CH  
1**ORDINANCE AMENDMENT REVIEW SHEET**

**Amendment:** C20-2013-001 Barton Springs Pool General Grounds Improvements

**Description:** Consider an ordinance to amend Chapter 25 of the City Code related to Barton Springs Pool General Grounds Improvement Project. This ordinance change will allow site specific amendments and variances. The proposed improvements include: new sidewalk, accessible route, underground utilities, and ticket booth in the critical water quality zone, and expanded parking in the water quality transition zone of Barton Creek.

Tree Court Improvements

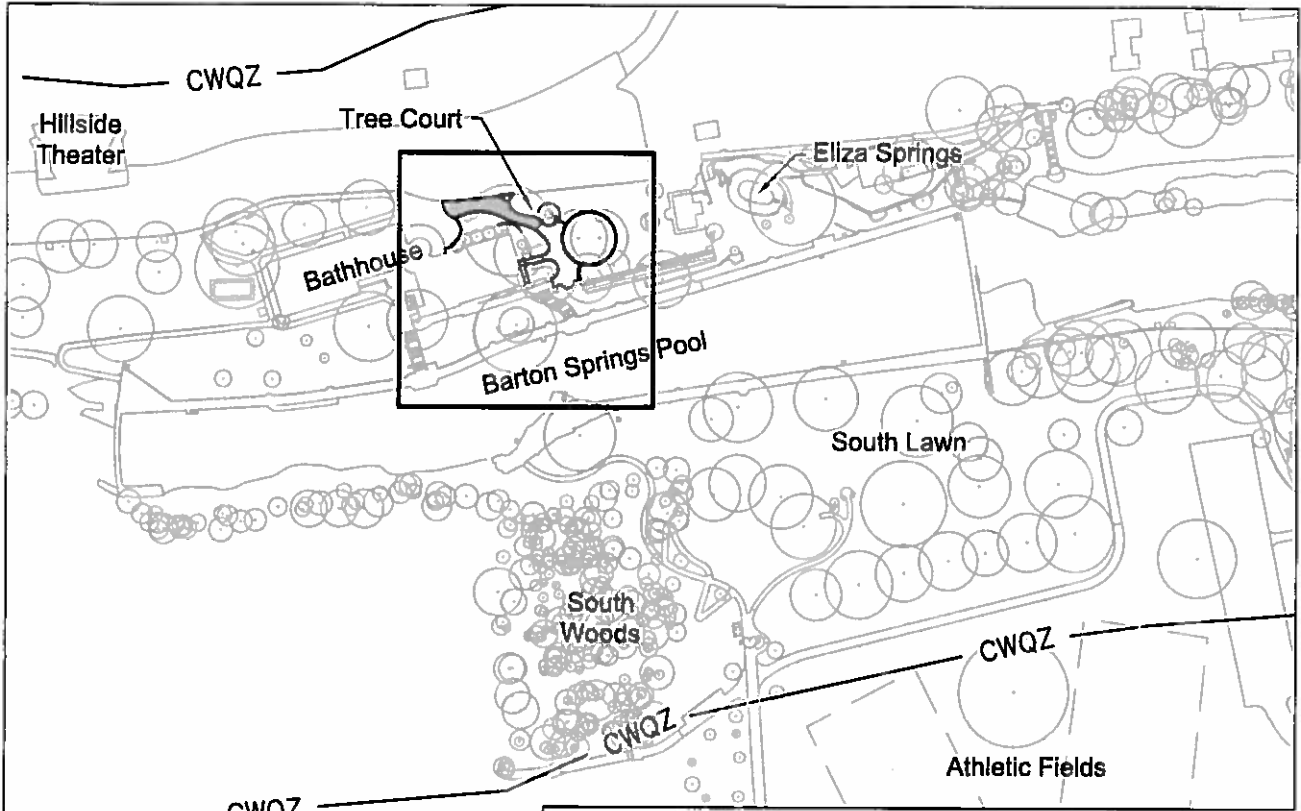
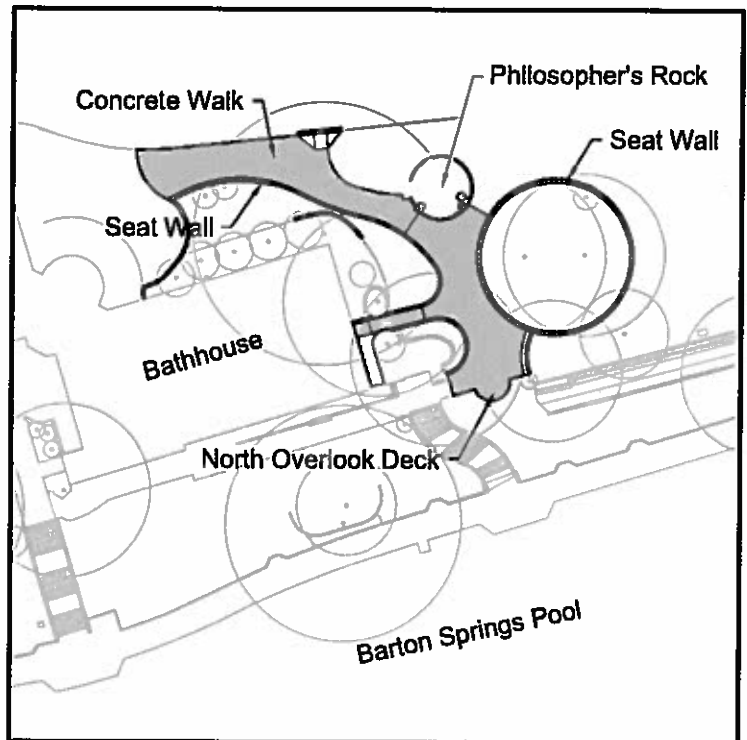
1. Tree Court Area:
  - a. The entire tree court area is treated as a Critical Root Zone.
  - b. Decomposed granite is removed from root zone areas and under walks to native grade.
  - c. Piers for the suspended walk are excavated with an air excavation tool for the first 2'.
  - d. Soil beneath the suspended walk is de-compacted after piers are poured.
  - e. An approved Certified Arborist or appropriate city staff be present during construction.
2. Remove the south overlook and pathway to the overlook from the plan.
3. Increase size of planting median in south parking lot area to 4000 SF and reduce the large maturing trees in the planting to two trees.

## South Overlook Trail

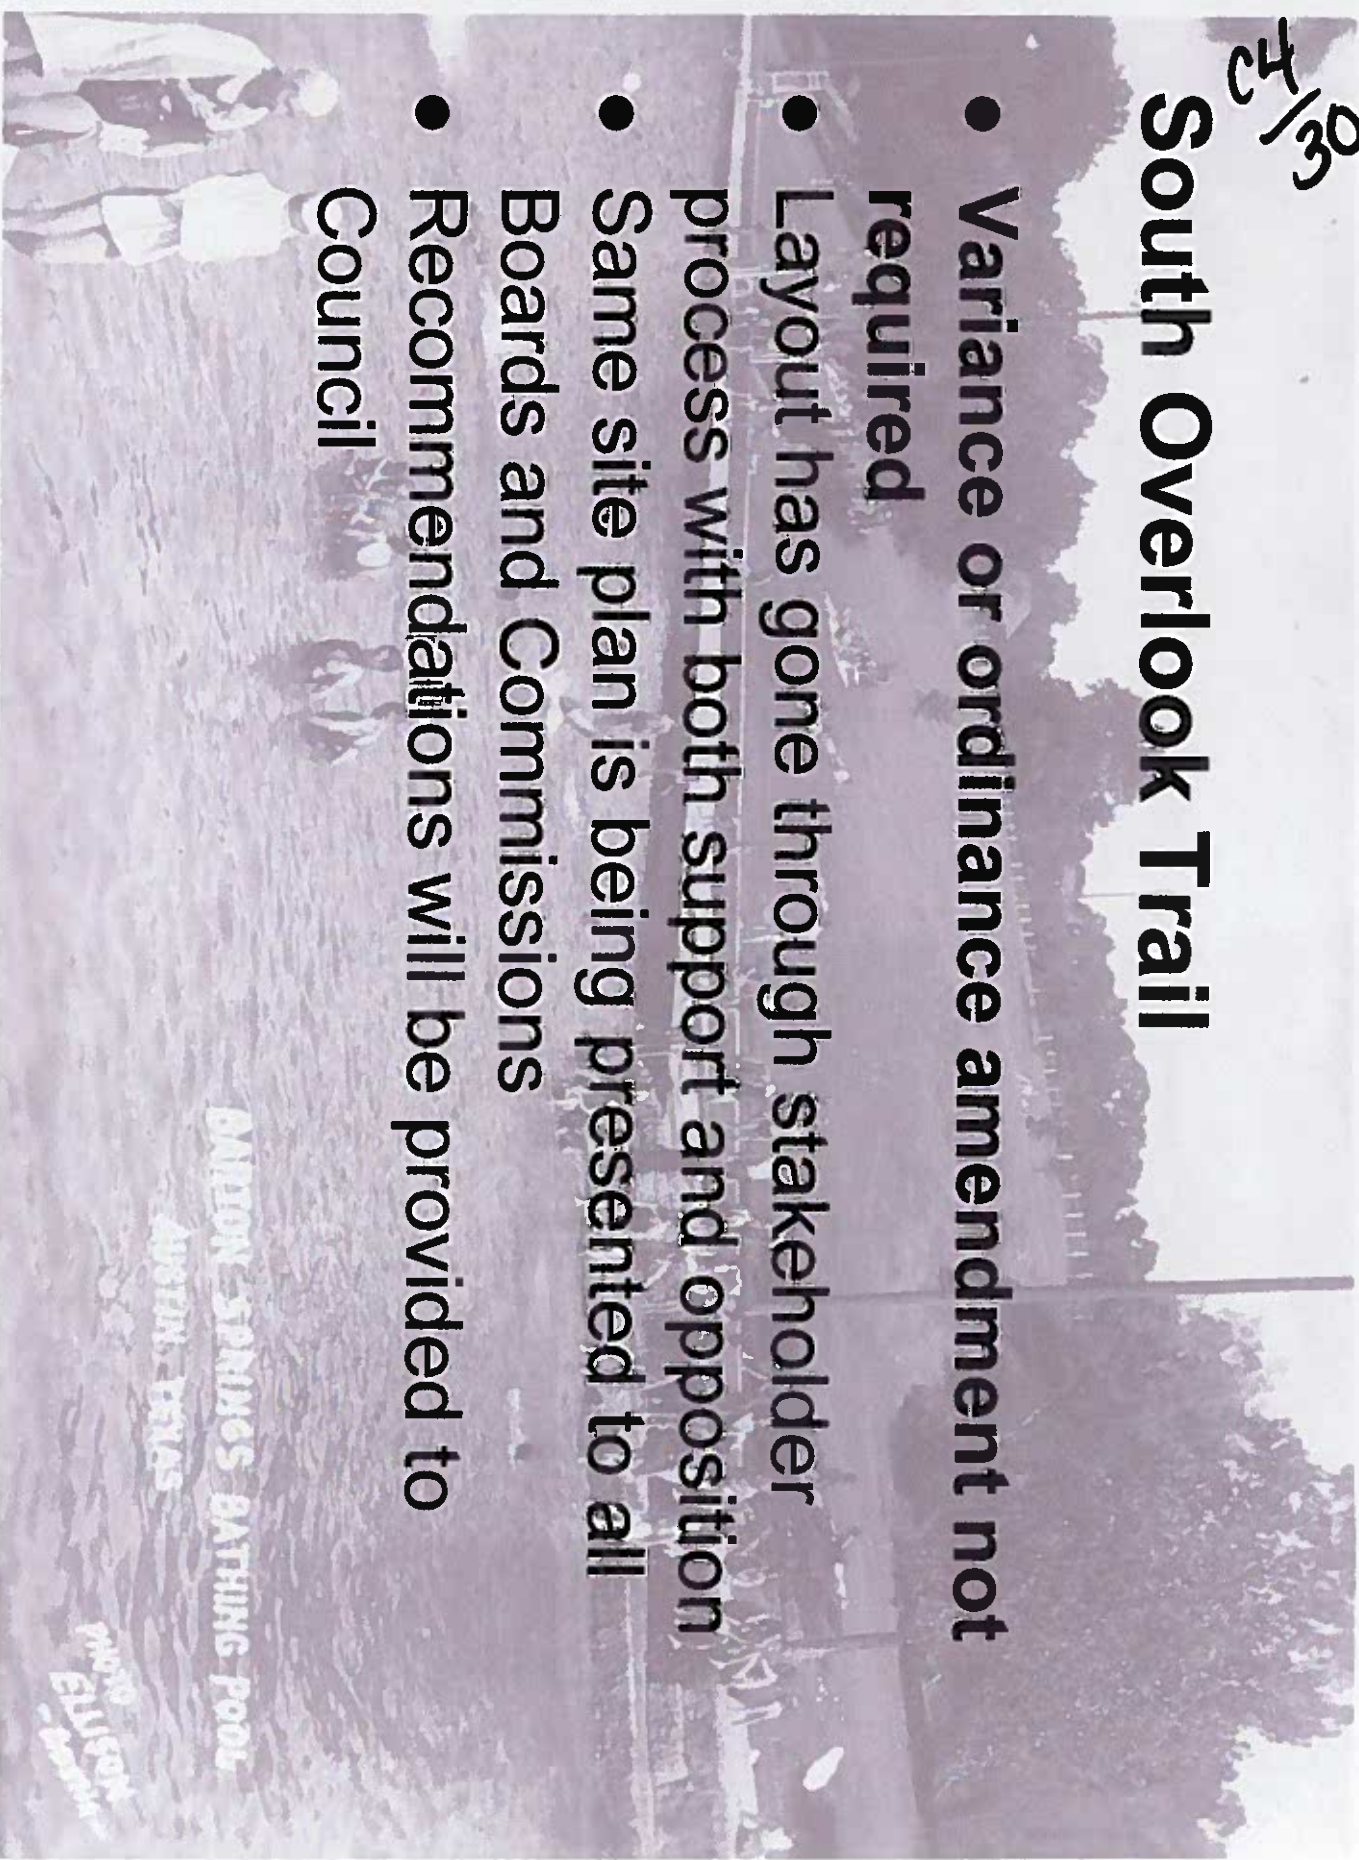
Voted to send this item to full Planning Commission on February 19, 2013, with direction to staff to remove the South Overlook from the plan, examine the feasibility of moving parking out of the Critical Water Quality Zone with the intent of maintaining the existing level of impervious cover. Vote: 6-0.

1. ADA Trail through the grass of the South Lawn and request planner and Parks Depart. staff look closer at a place for that overlook away from the South Lawn
